## TEXAS COMMISSION ON ENVIRONMENTAL QUALITY

NAME OF PROJECT: Community Center Manor Creek; located approximately 2 miles west of Loop 337 on the northeast side of SH State Highway 46; New Braunfels, Texas

TYPE OF PLAN: Request for Approval of a Water Pollution Abatement Plan (WPAP); 30 Texas Administrative Code (TAC) Chapter 213 Edwards Aquifer;

Re: Edwards Aquifer, Comal County  
NAME OF PROJECT: Community Center Manor Creek; located approximately 2 miles west of Loop 337 on the northeast side of SH State Highway 46; New Braunfels, Texas  
TYPE OF PLAN: Request for Modification of an Approved Water Pollution Abatement Plan (WPAPMOD); 30 Texas Administrative Code (TAC) Chapter 213 Edwards Aquifer;  
Edwards Aquifer Protection Program ID No. 2439.04; Investigation No. 792433; Regulated Entity No. RN105881080

Apparent  
Uncaptured  
areas

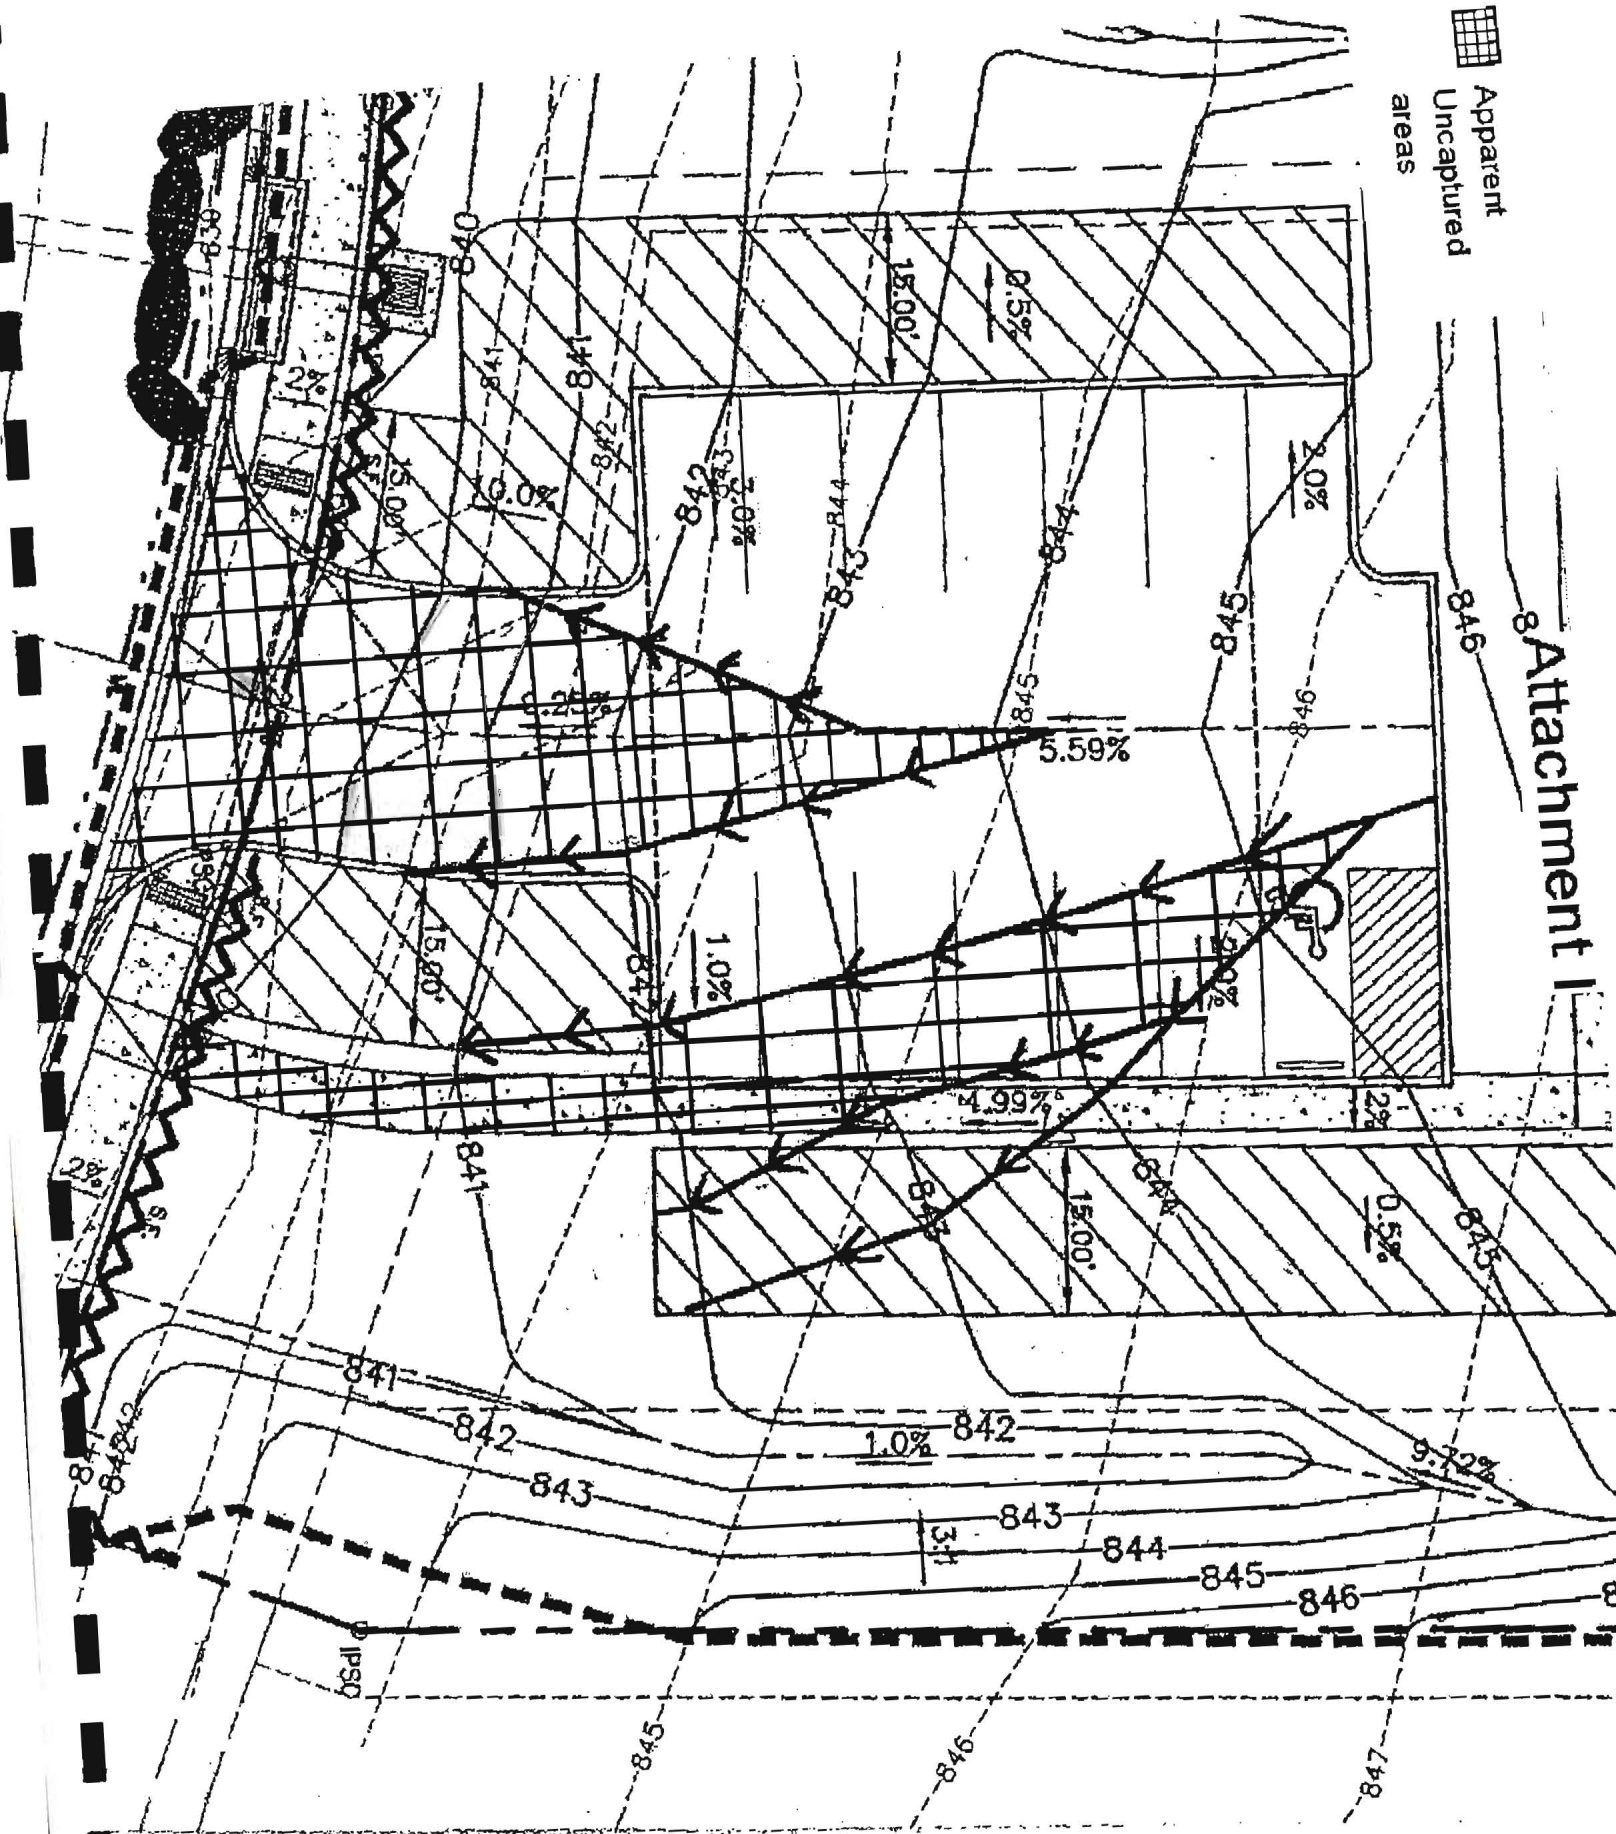
Site Plan Concerns:

2. How will roof runoff from the proposed building be directed into the proposed VFS without concentrating flow into or causing erosion to the VFS?
3. Demonstrate how stormwater runoff from the parking lot and driveway will enter the VFS (i.e. ribbon curbs, saw-tooth curb, etc.)
4. According to the proposed contours stormwater runoff from parts of the driveway, parking lot, and sidewalk will not flow to a VFS or will pass through less than 15 feet of VFS (see Attachment D). Please explain and revise as necessary.
